TECHNICAL EVALUATION OF THE ELECTRICAL,
INSTRUMENTATION, AND CONTROL DESIGN ASPECTS
OF THE LOW TEMPERATURE OVERPRESSURE PROTECTION
SYSTEM FOR THE KEWAUNEE NUCLEAR POWER PLANT

V. R. Latorre

May 1980

Figure 1. Flow diagram of residual heat removal system.

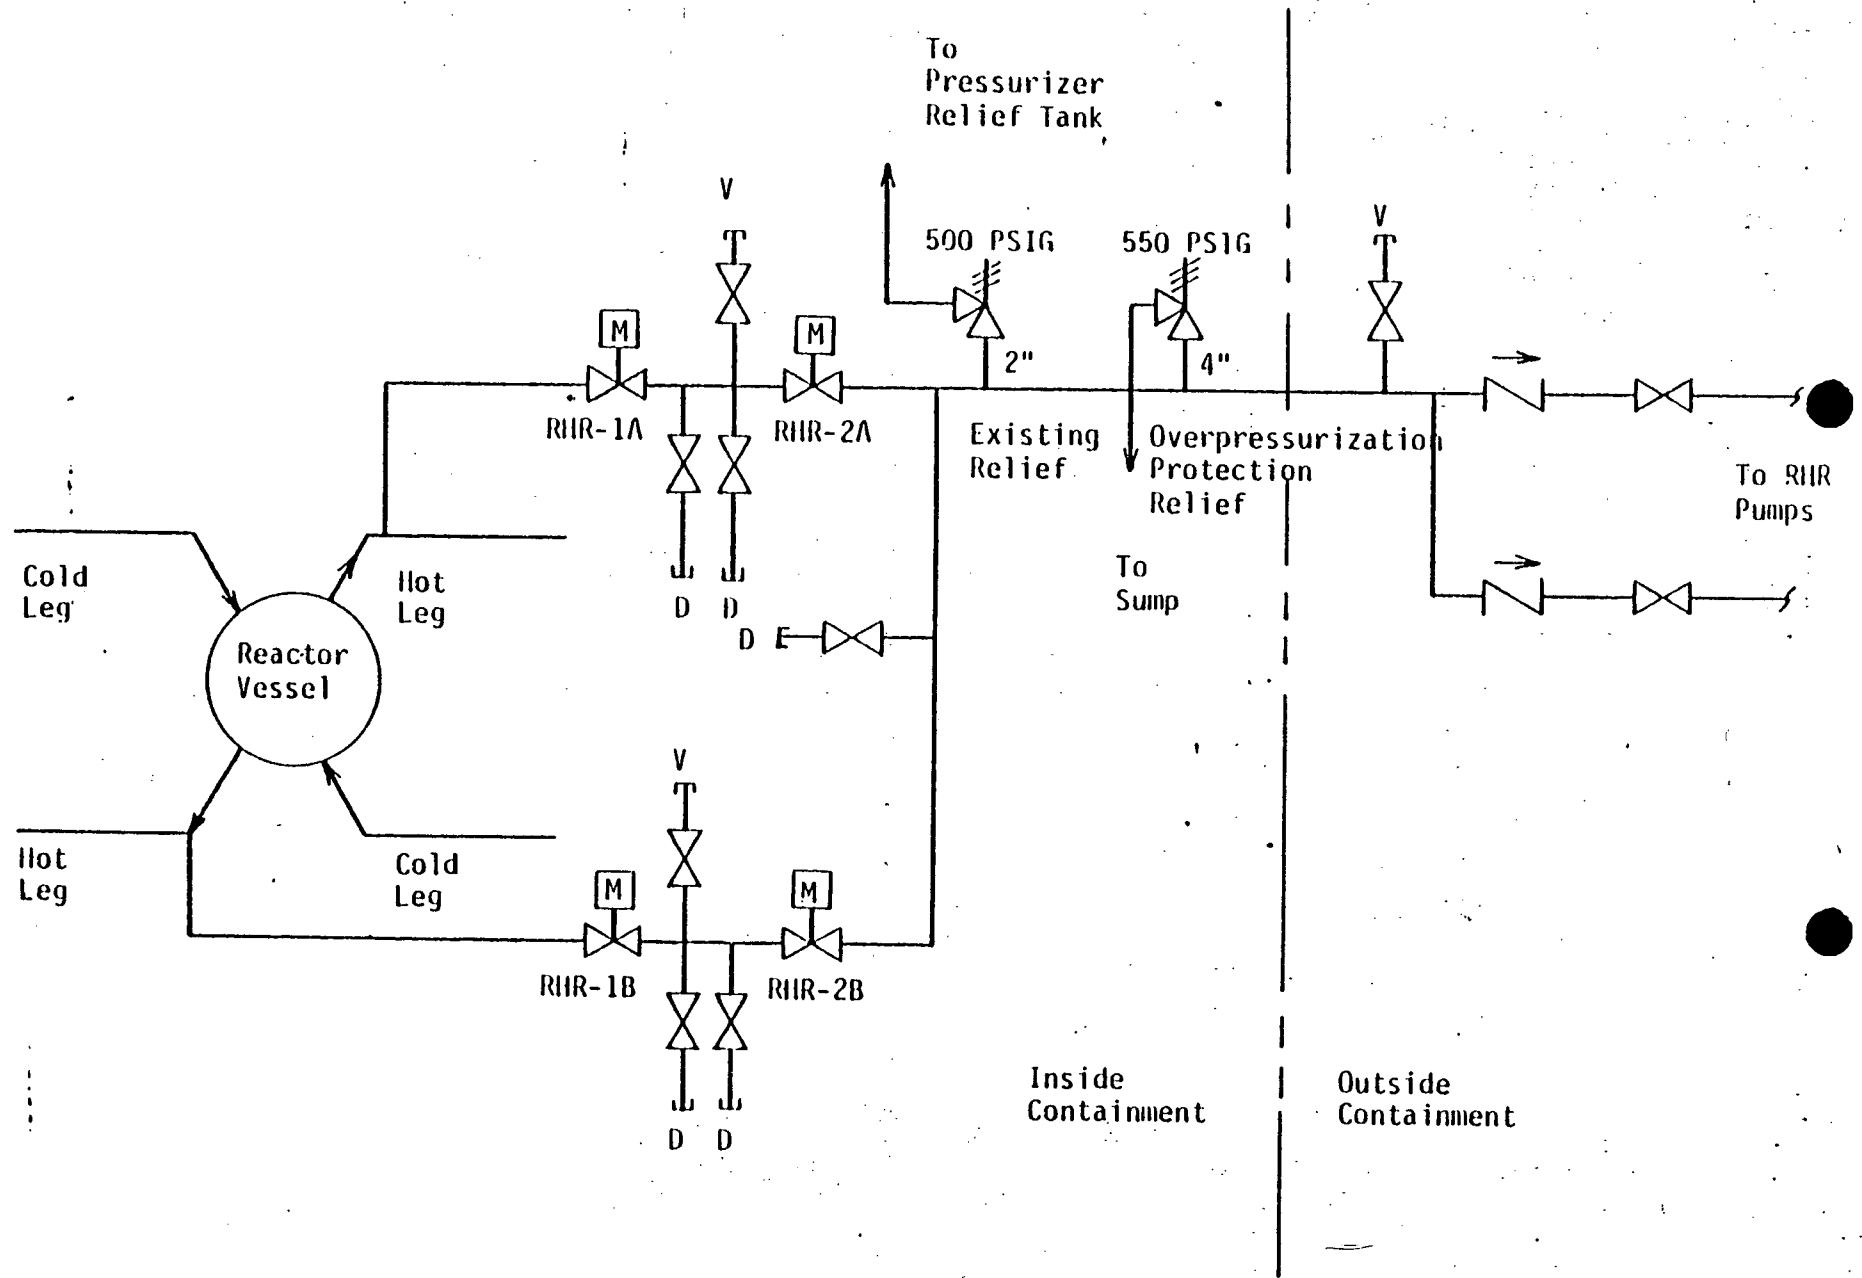
Figure 1 presents a section of the residual heat removal system (RHR) flow diagram which identifies the location of the proposed overpressurization relief valve in relationship to the reactor coolant system and the remainder of the RHR system. As noted in Figure 1, the relief valve would be located within containment on the common-normal suction header to the RHR pumps downstream of the isolation valves from the RCS. The existing RHR relief valve will be retained at a setting lower than the planned overpressurization relief valve to provide relief from small flow-rate transients, thereby avoiding operation of the large overpressurization relief at low flowrates. The overpressurization relief valve will discharge to the containment sump, since at the maximum possible anticipated flowrates the discharged water would rupture the PRT rupture disk and ultimately would collect in the sump in any case.

Figure 2. Kewaunee control circuitry.

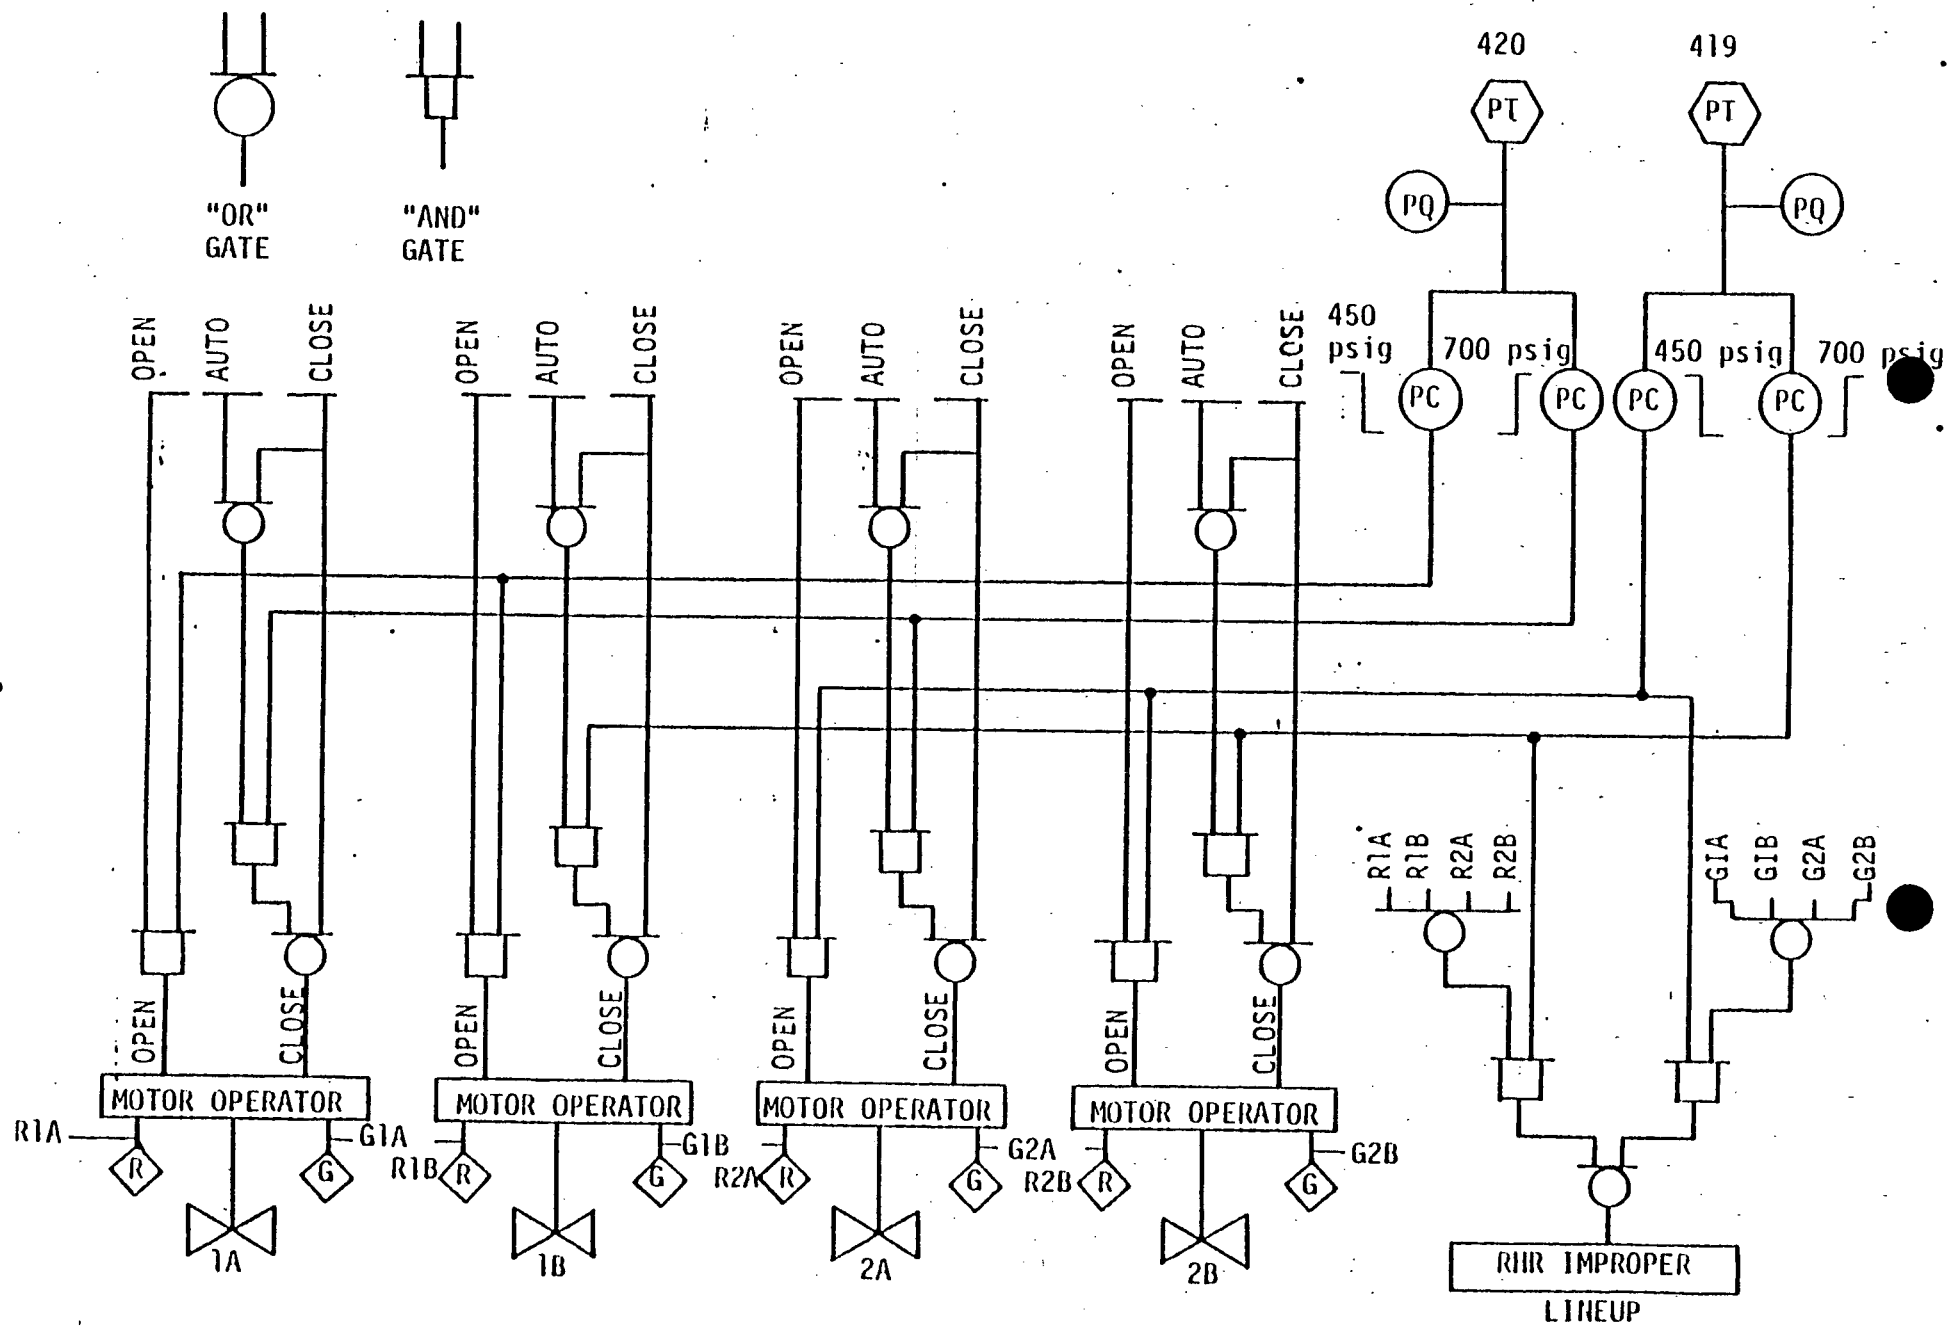
One interpretation of the single failure criterion would indicate that the control circuitry shown in Figure 2 fails to satisfy the criterion because one failure would deny use of the OPS to the plant. This situation exists because if either of the pressure transducers (PT 419 or PT 420) or the associated circuitry fails, neither leg of the RHR system would open, since each of these channels controls two MOV isolation valves (one in each leg, as shown in Figure 1). It is concluded, however, that the OPS control circuitry does satisfy the single failure criterion, based on the following:

- (1) At plant temperatures at which the OPS would normally be activated, the Appendix G limits will not be exceeded.
- (2) The plant Technical Specifications permit the plant to operate at hot standby for an indefinite period.
- (3) Operational procedures should allow plant personnel to either correct the malfunction or enable the system by other means.
